Appendix A - Item 20

PPL Bell Bend Nuclear Power Plant
Salem Township, Luzerne County, PA

Bell Bend Nuclear Power Plant Site
Stream Widths (in feet) at the ordinary high water mark

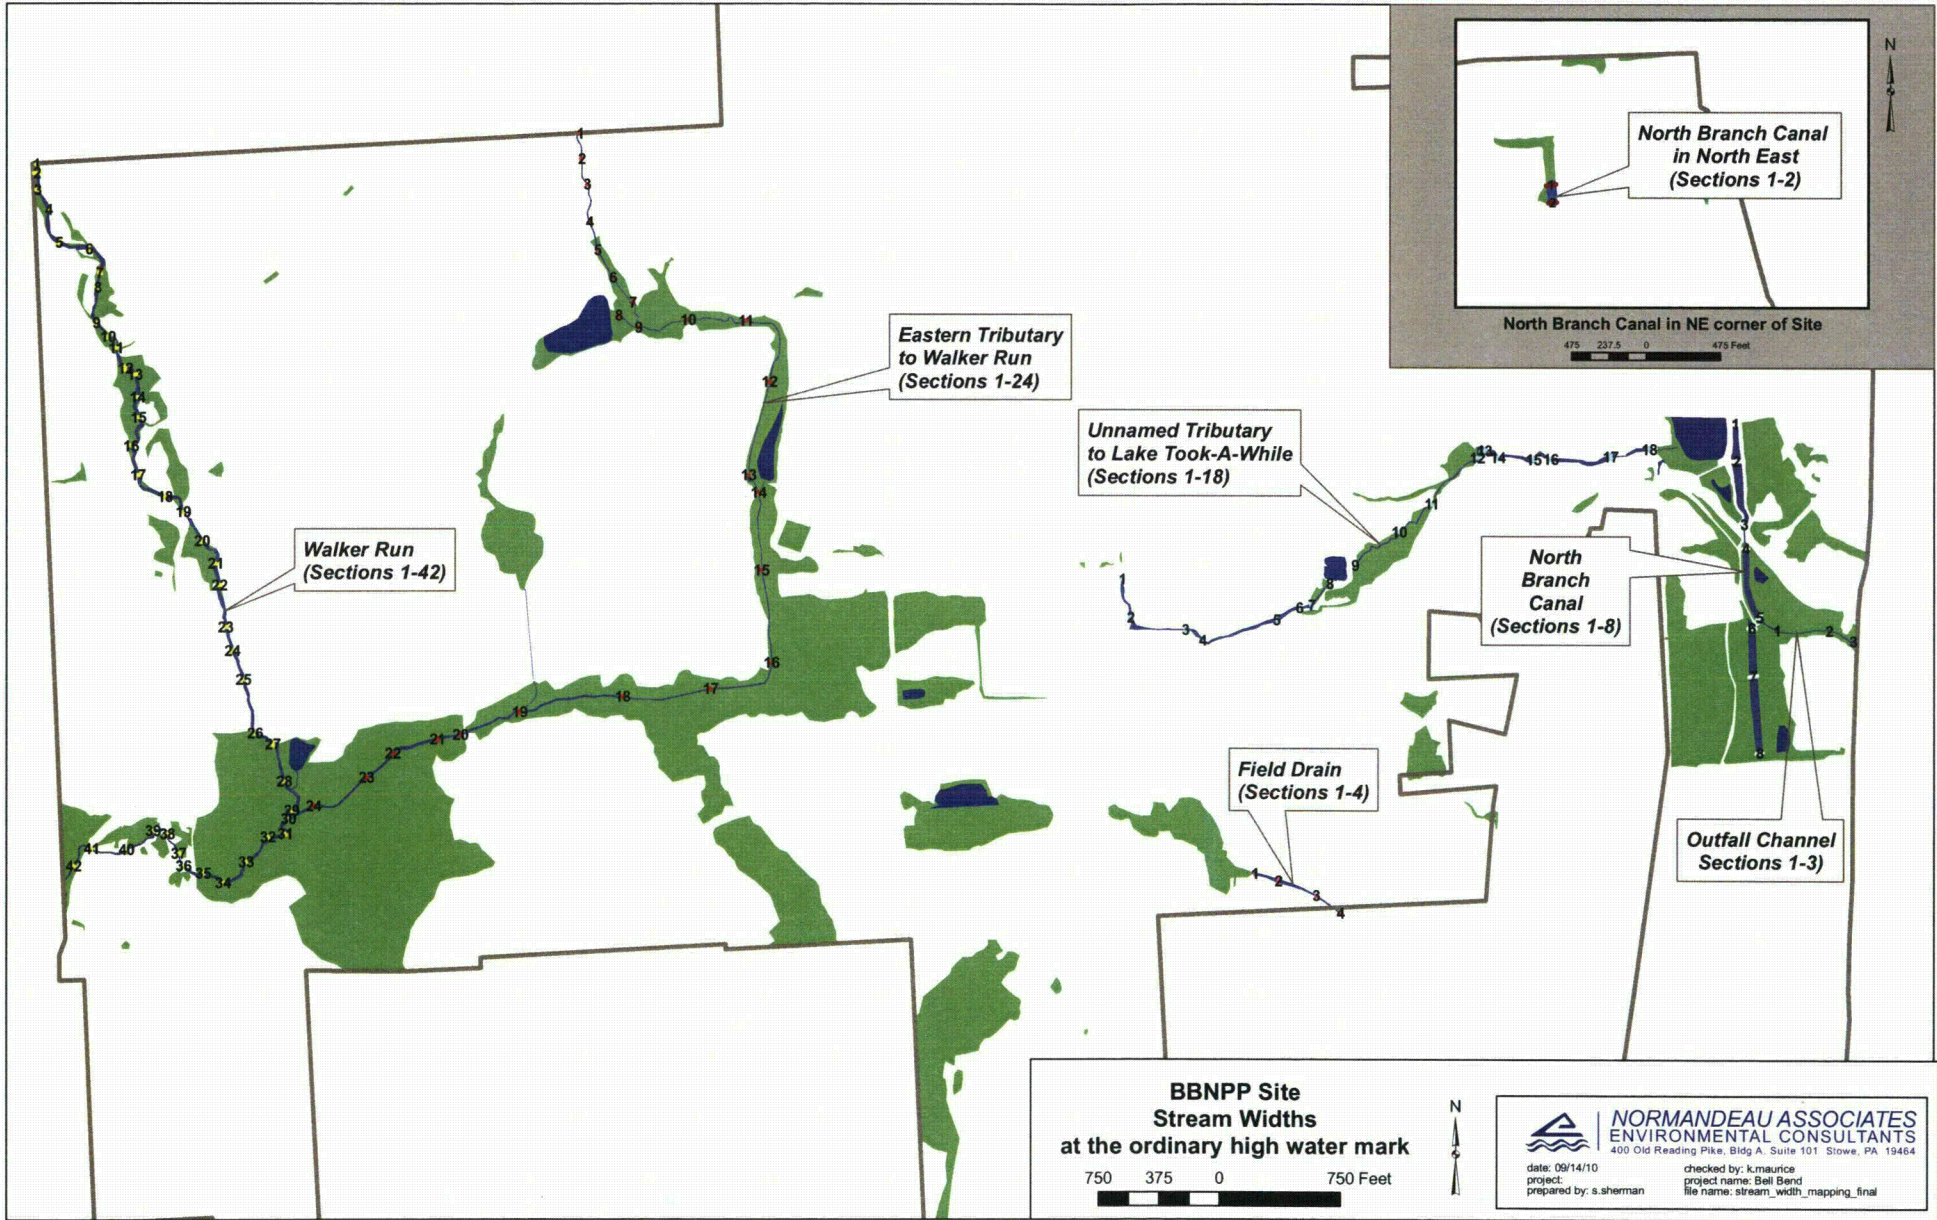
“Indicate the length and average width at the approximate ordinary high water mark of each stream proposed to be impacted. Indicate the total length and area of the stream to be impacted. Indicate the latitude and longitude coordinates of each stream proposed to be impacted at the upstream and downstream proposed impact limits, describe the condition of the stream in the proposed impact area.”

See attached map and table for the length and average width at the approximate ordinary high water mark of each stream with proposed impacts.
